SR 40 PD&E Study

From Breakaway Trail to Williamson Boulevard

Final Location Hydraulic Report

Volusia County, Florida
Financial Project ID: 428947-1-22-01

SHEET NO.
 8

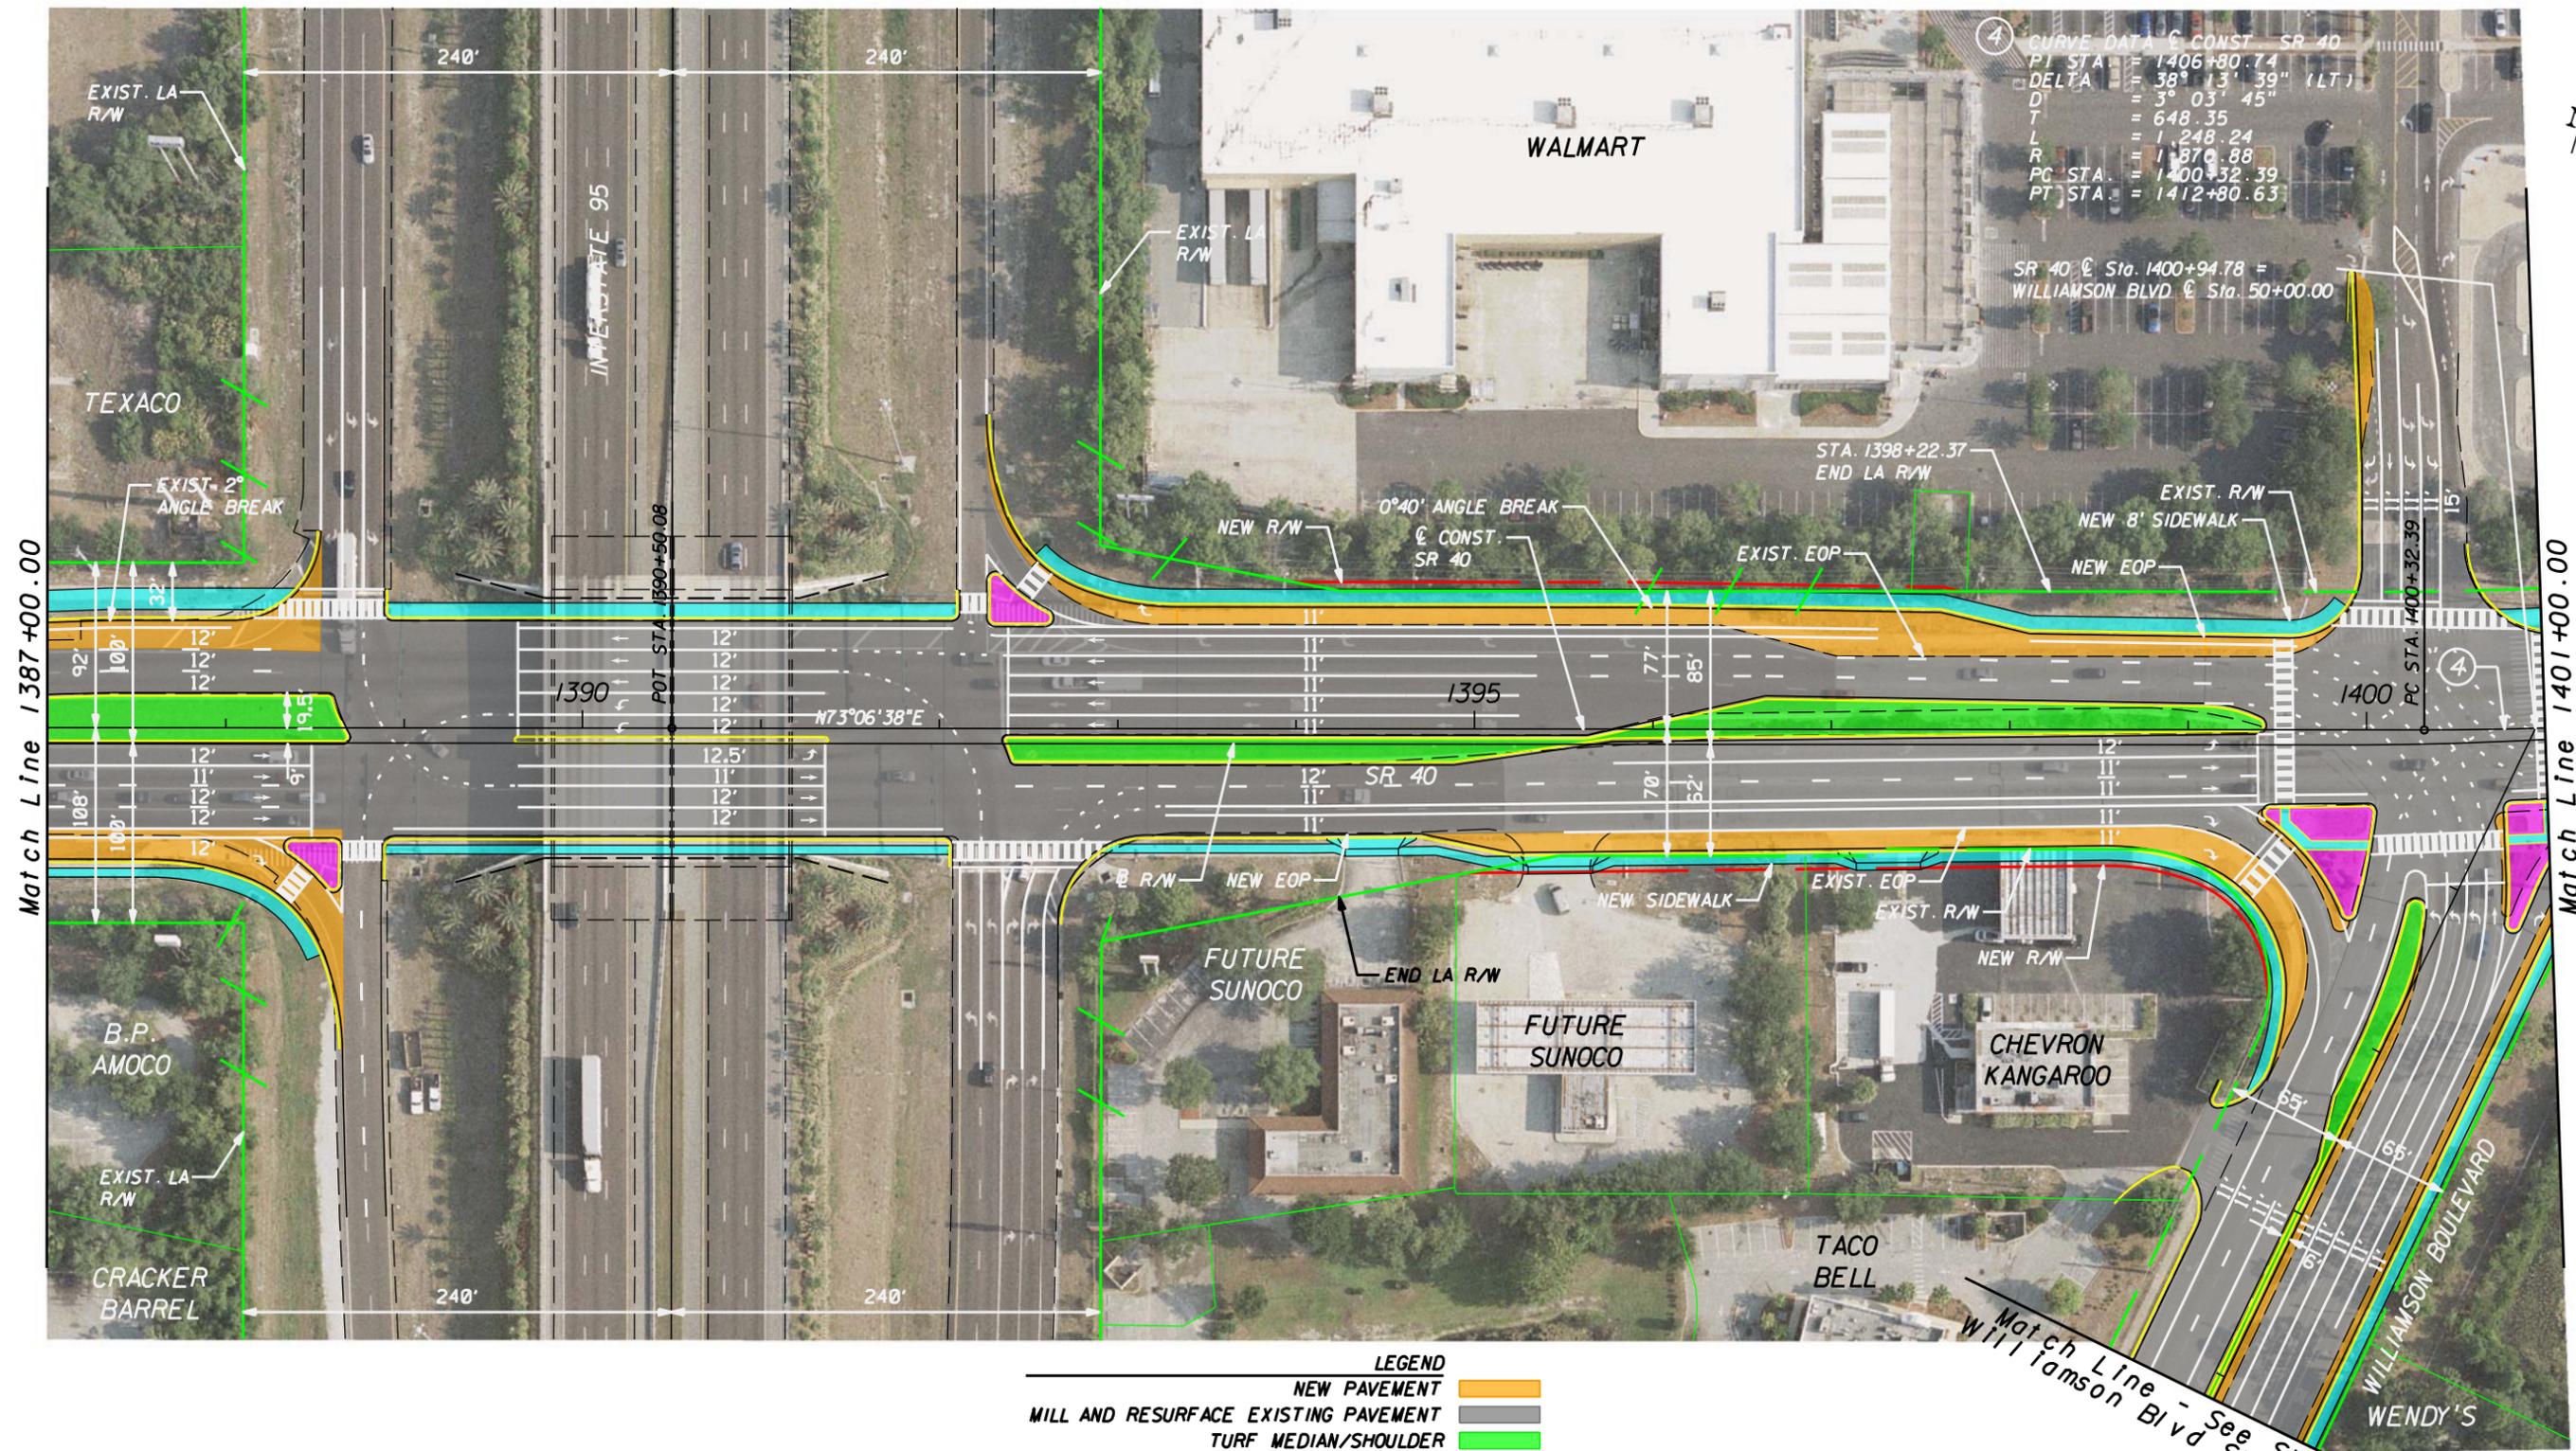
Sheet #8 – We had extensive discussion of the SR 40 and Interchange Boulevard intersection. This intersection is currently being evaluated by FDOT Traffic Operations to be modified from full access to WB directional access. FDOT has received a public inquiry to Secretary Prasad about the intersection modifications. The discussion at the meeting was to keep the directional access but increase the length of the WB left turn lane for additional storage should the intersection become signalized in the future. The design should also be modified to delete the concrete traffic separator and place the left turn lane adjacent to the thru lane. It was also noted that the left turn radius should be checked to accommodate a WB-67 truck for Race Trac. Following the meeting and review of the e-mail exchange from the inquiry to Secretary Prasad, a request has been sent to FDOT to show full intersection access at this location for upcoming public meetings. It also requested that the plans identify where the existing posted speed limit changes from 45 mph to the east to 50 mph to the west. The EB right turn lane to the I-95 SB entrance ramp should be shortened to begin just after the southeast radius return at Interchange Boulevard.

SHEET NO.
9

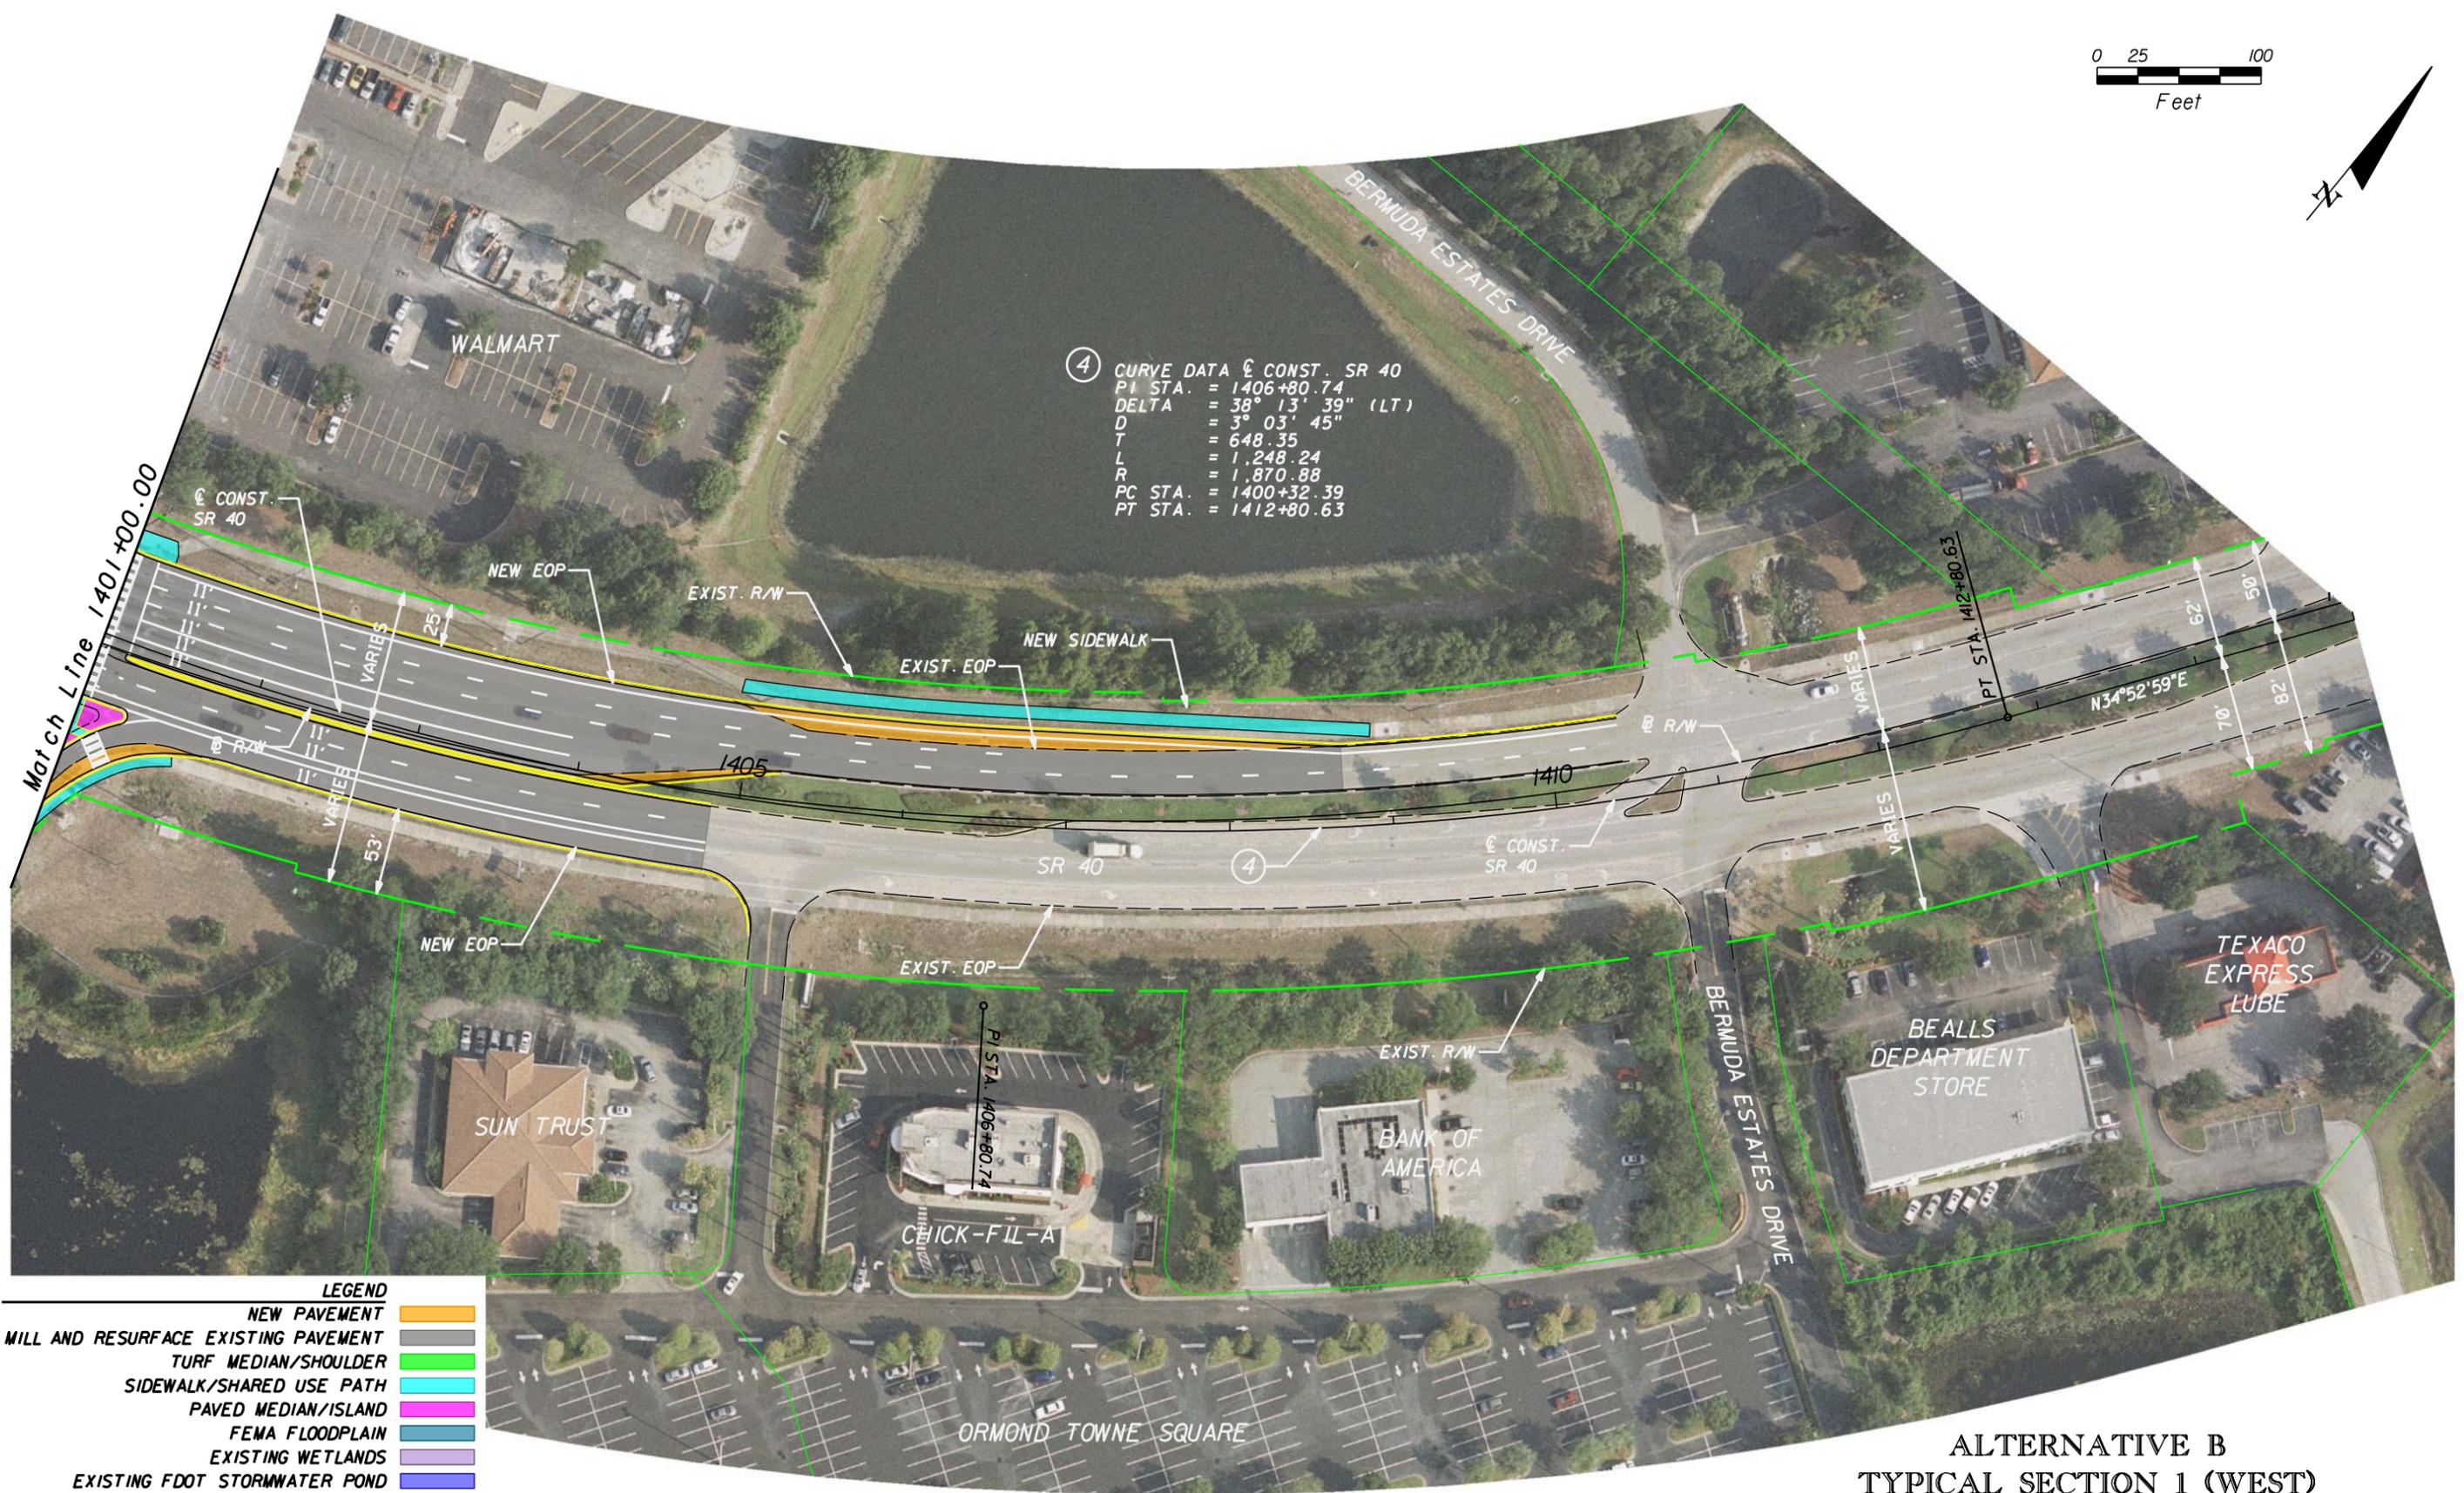
Sheet #9 – It was noted that this plan sheet is the same for both alternatives since there are six lanes on SR 40 under I-95 and there is limited right-of-way between I-95 and Williamson Boulevard. The input received was to show a pedestrian crosswalk for the multi-use path across the WB right turn lane to I-95 NB entrance ramp. We also discussed the potential for modifying the recommended intersection lane geometry at the SR 40 and Williamson Boulevard intersection to have the third NB left turn lane be a shared left turn and thru movement. We have requested additional traffic analysis at this intersection to see if this is possible as it can avoid expensive right-of-way in the southeast intersection quadrant if possible.
